Subject: Issuance of Amendment No. 34 to Facility Operating License NPF-35
and Amendment No. 25 to Facility Operating License NPF-52 - Catawba
Nuclear Station, Units 1 and 2 (TACs 59641/60928)

AMENDMENT NO. 34 TO FACILITY OPERATING LICENSE NPF-35 -
CATAWBA NUCLEAR POWER STATION, UNIT 1
AMENDMENT NO. 25 TO FACILITY OPERATING LICENSE NPF-52 -
CATAWBA NUCLEAR POWER STATION, UNIT 2

SAFETY EVALUATION BY THE OFFICE OF NUCLEAR REACTOR REGULATION
RELATED TO AMENDMENT NO. 34 TO FACILITY OPERATING LICENSE NPF-35
AND AMENDMENT NO. 25 TO FACILITY OPERATING LICENSE NPF-52
CATAWBA NUCLEAR STATION, UNITS 1 AND 2
DUKE POWER COMPANY, ET AL.

FIGURE 3.2-3
REACTOR COOLANT SYSTEM TOTAL FLOW RATE VERSUS R - FOUR LOOPS IN OPERATION

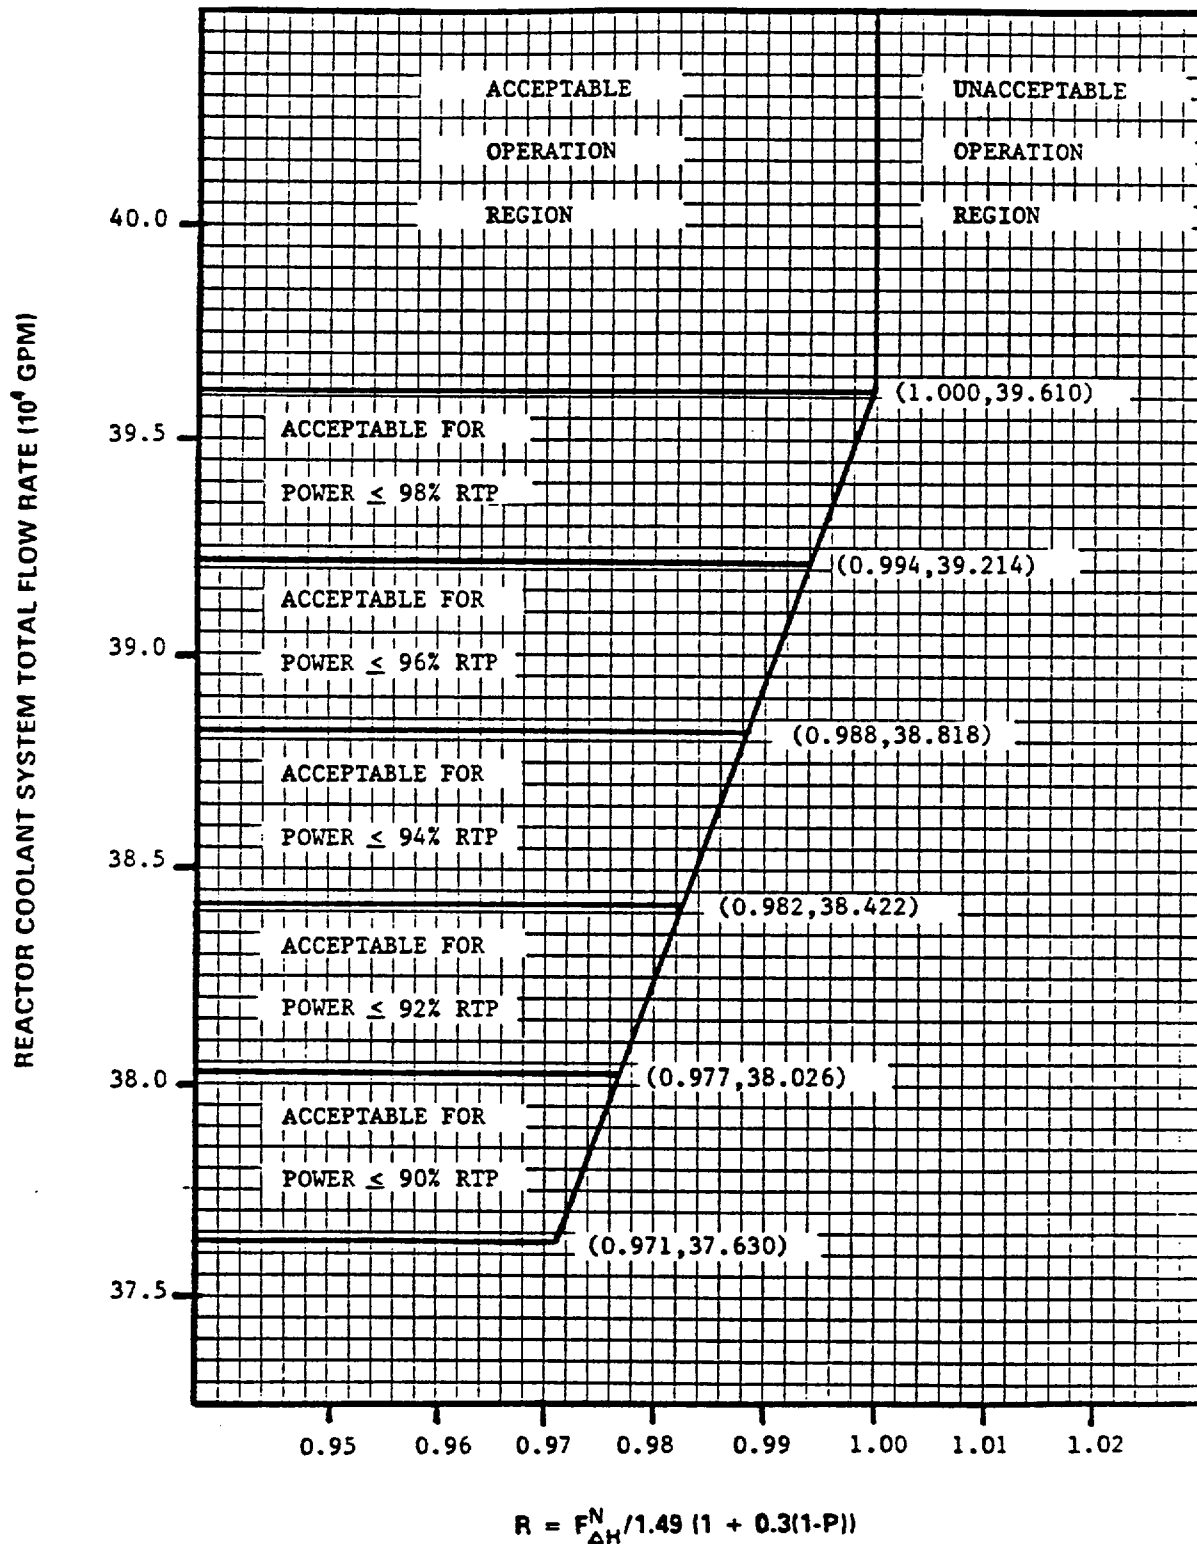
The amendments would add an action statement to Technical Specification 3/4.2.3, and would modify Figure 3.2-3 to delete the DNB limit line and add a graduated scale to allow a tradeoff of reactor coolant system flow against reactor thermal power level. The amendments are effective as of the date of issuance.

By letter dated July 31, 1985, and supplemented November 8 and December 26, 1985, and March 7, 1986, Duke Power Company, et al., (the licensee) proposed changes to Figure 3.2-3 of Technical Specification (TS) 3/4.2.3 for Catawba Nuclear Station, Units 1 and 2. The changes would delete the DNB limit line and add a graduated scale to allow tradeoff of reactor coolant system (RCS) flow against reactor thermal power (RTP) level.

The licensee proposes that Figure 3.2-3 titled "Reactor Coolant System Total Flow Rate Versus R-Four Loops in Operation" be modified to permit operation at a reduced flow rate (i.e., about 95% of full flow) which would be compensated by an appropriate reduction in reactor power level. The reduced power level ensures that the thermal margin is maintained at a value equivalent to that for full flow. In addition, the licensee proposes to delete the DNB limit line to prevent operation misinterpretation because the rod bow factor (R_b) is not associated with TS 3/4.2.3 or Figure 3.2-3 and thus the DNB limit line serves no useful purpose.

The licensee proposes to reduce RTP level by 2% for each 1% reduction in the measured RCS flow below the TS flow requirement for 100% power which is equal to 396,100 gpm. Westinghouse calculations show, with penalties added for conservatism, that a 5% reduction in flow results in a 4.4% reduction in power. The staff's independent audit (using W-3 correlation sensitivity factors reported in References (1) and (2)) show that, for the worst case reported in Reference (2), a 5% reduction in flow requires a 4.32% reduction in power. The licensee's plan to use a 10% reduction in power for a 5% reduction in flow is conservative. Furthermore, this ratio of RTP level to RCS flow was used for the McGuire Nuclear Station TS and has been reviewed and approved by the NRC staff.

Based on the above evaluation, the staff concludes that the proposed modification to Figure 3.2-3 of TS 3/4.2.3 for using a 2/1 power to flow relationship for a maximum of 5% reduction in flow is acceptable.

The staff also finds the elimination of the DNB limit line in Figure 3.2-3 to be acceptable as it was originally for an " R_2 " value associated with rod bow penalty. In the November 8, 1985, letter, the licensee stated that a rod bow penalty is not applied to Catawba as there is approximately 10% margin between the safety analysis and design limit DNBR values. This is partially used to offset a 2.7% DNBR rod bow penalty. The staff agrees with the licensee's statements and licensee's treatment of rod bow penalty.

The licensee has factored the 2/1 power to flow tradeoff into the F Delta-H equation and in Figure 3.2-3. For example, at the maximum power reduction of 10% corresponding to a flow reduction of 5% and with F Delta-H maintained at the full power value of 1.49, the value of R is 0.971. This condition is shown in Figure 3.2-3 where RTP equals 90% and the RCS flow is 95% of the required flow or $.95 \times (396,100 \text{ gpm}) = 376,3000 \text{ gpm}$.

The limitation placed on F Delta-H for reduced RCS flow conditions prevents the usual allowance for increasing F Delta-H at reduced power levels. Reductions in power levels combined with a RCS flow deficiency and increased radial peaking do not maintain DNBR margin and thus the F Delta-H restrictions in Figure 3.2-3 are required.

Based on its review, the staff finds that Figure 3.2-3 was appropriately adjusted and, therefore, it is acceptable.
